Authors' Response to Report #1

- Authors Brandon C. White, Brian R. Elbing, and Imraan A. Faruque

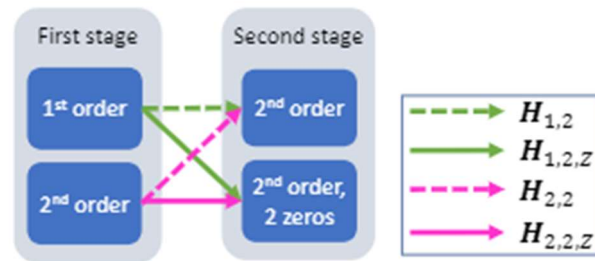
P9L183: Fig. 6 is missing(?). Only a caption appears.

Figure 6 has been appropriately compiled into the document and now appears above its appropriate caption. It is additionally included here for reference.
